UNITED STATES PATENT AND TRADEMARK OFFICE

10/822,101

Office Action Summary	Application No.	Applicant(s)	
	10/822,101	TUCCARONE ET AL.	
	Examiner	Art Unit	
	Mary Hoffman	3733

DETAILED ACTION

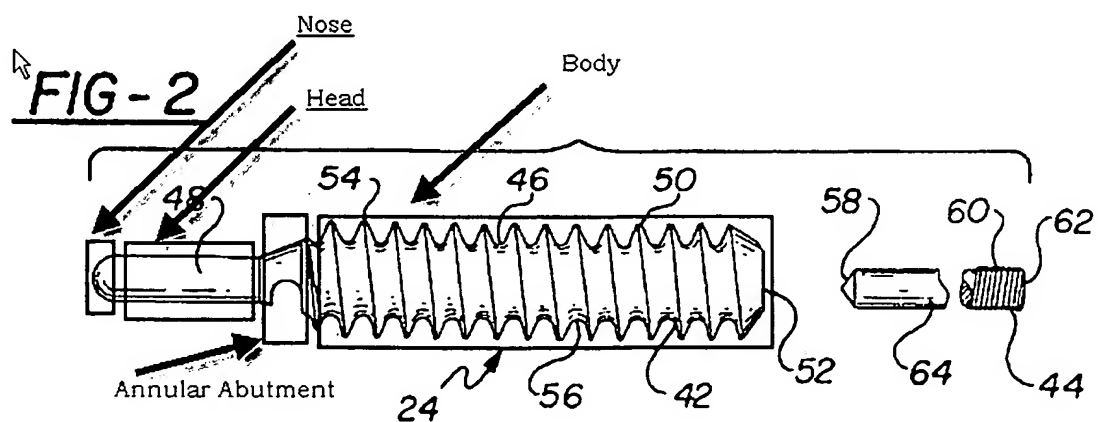
Howell et al. disclose a method of ACL graft ligament fixation comprising the steps of providing a transverse suspension device comprising a proximal body section defining a longitudinal axis, a head section extending along the longitudinal axis and protruding distally from the body section, the head section having a smaller diameter than that of the body section, and an annular abutment surface disposed between the head section and the body section wherein the abutment surface is substantially at an angle to the longitudinal axis (FIGS. 2-3); forming a femoral tunnel and forming a transverse tunnel intersecting the femoral tunnel (FIG. 10); locating a graft loop in the femoral tunnel in such a manner that an open face of the loop faces an intersection

where the femoral tunnel intersects the transverse tunnel FIGS. 11-12); passing at least a part of the head section of the transverse suspension device through the graft loop via the transverse tunnel until the head section contacts a recess formed in an opposite wall of the femoral tunnel wherein the abutment surface urges the graft against the opposite wall (FIG. 14). A guidewire is advanced under observation with a viewing device, specifically an arthroscope (col. 6, lines 37-53). The recess is formed with a dilator tool (ref. #124). The transverse suspension device is cannulated. The transverse tunnel is drilled to intersect and not cross the femoral tunnel. The body section comprises external threads. The device includes a nose section distal to and distinct from said head section and having a reduced diameter as compared to said head section, said nose section extending along said longitudinal axis, and an annular abutment surface distinct from said head section and disposed between said head section (see marked up figure below). The angle is about 90 degrees and the head section has a substantially constant diameter.

Applicant argues that the device of Howell et al. does not show a nose section, a head section, an abutment surface, and a proximal body section. As shown in the above marked up figure, the Howell et al. reference does disclose these features. It is noted that the recitation "distinct" is not sufficient to distinguish the current invention from the prior art, as one of the definitions of distinct is "distinguished as not being the same; not identical; separate" [Dictionary.com] and the Howell reference clearly shows this.
